Serial: RNP-RA/05-0107

H. B. ROBINSON STEAM ELECTRIC PLANT, UNIT NO. 2
DOCKET NO. 50-261/LICENSE NO. DPR-23

REQUEST FOR TECHNICAL SPECIFICATIONS CHANGE TO
SECTION 3.8.1 FOR THE DIESEL GENERATOR AUTOMATIC TRIPS BYPASS

**EMERGENCY DIESEL GENERATOR
 PROTECTIVE BYPASSES
 FIGURE 1**

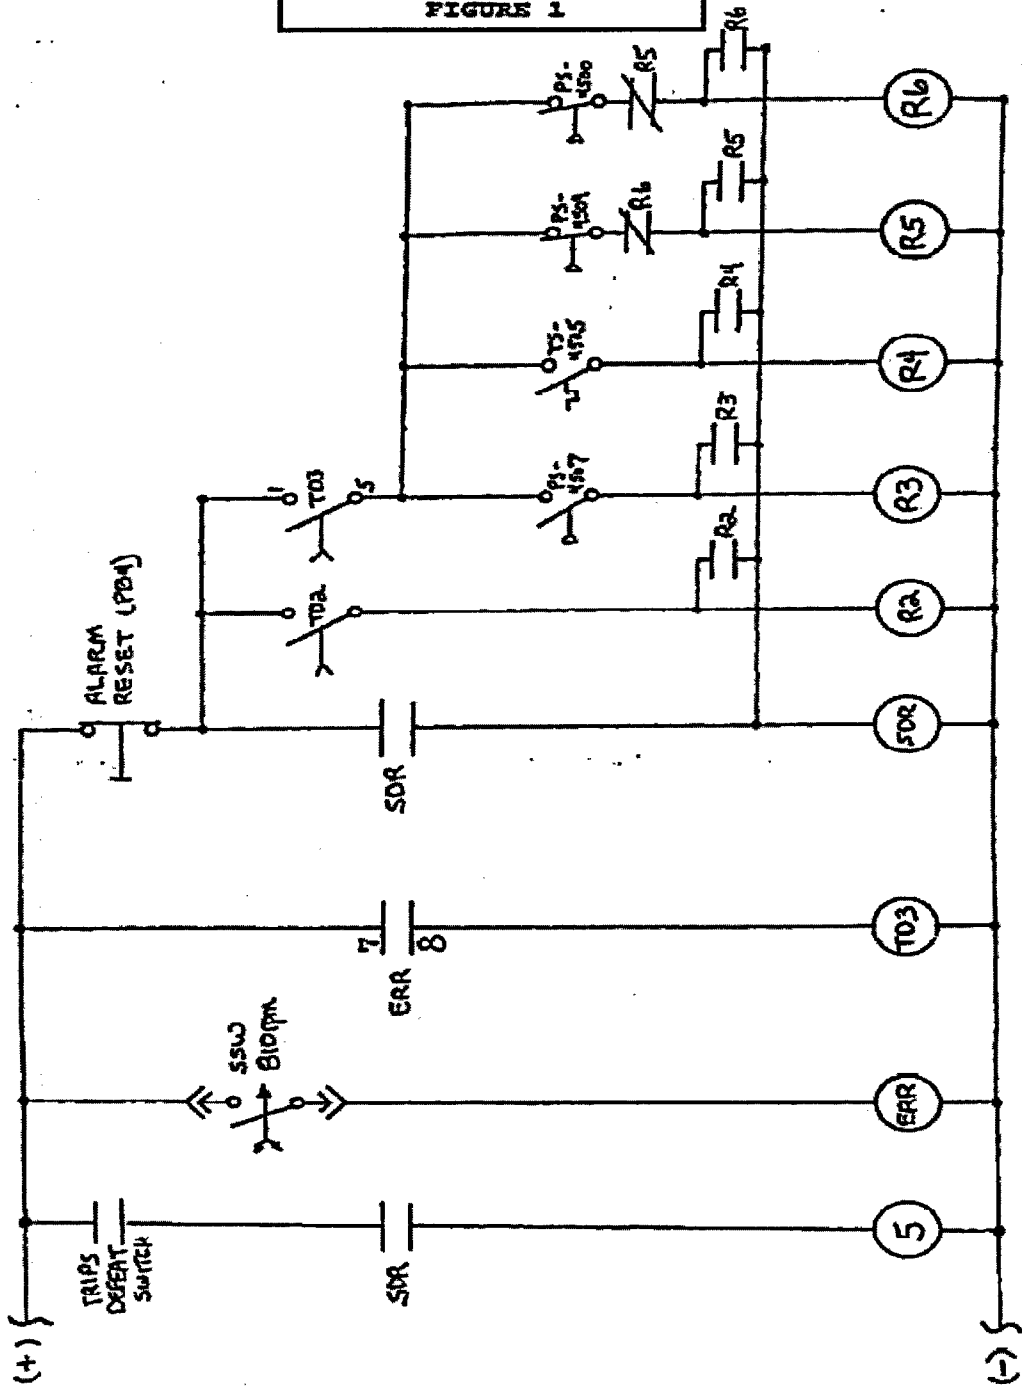
As part of Amendment No. 174, substantial technical information was provided to the NRC pertaining to the trips bypass (also called trips defeat) switch, including a simplified circuit diagram which is provided as Figure 1 in this attachment. The basic test sequence for the completion of SR 3.8.1.11 is provided, as follows:

1. The trips defeat switch is verified to be in the "Trips Defeat" position.

2. The emergency DG trouble alarm is verified to be clear (not illuminated).
3. A jumper is connected across the Alarm Delay Relay (terminals 1 and 5). This simulates engine running conditions for the non-critical trip functions.
4. A voltmeter is connected across the coil on the Stopping Relay.
5. The four non-critical trip functions are actuated one at a time by placement of a jumper in the actuation circuit for each non-critical trip. The associated alarm for each non-critical trip function is verified and the voltage on the Stopping Relay coil is verified to remain 0 volts. This verifies that actuation of each of the non-critical trips is occurring and that the Stopping Relay is not actuated.

The purpose of the trips defeat switch is to improve the likelihood that the DG will not trip during an emergency condition in which the DG is required to provide power to the associated emergency bus. The trips bypass function is only needed if a spurious or unexpected trip of any of the non-critical trip functions were to occur. Although not quantified, it is unlikely that one of the non-critical trips would occur under emergency conditions. Further, if a valid non-critical trip were to occur during required emergency operation of the DG, there is some (not quantified but finite) probability that the malfunction causing the non-critical trip would result in DG failure regardless of the function of the trips defeat circuitry. The failure of a single DG is within the design basis for HBRSEP, Unit No. 2. There are two DGs and only one is required for accident mitigation.
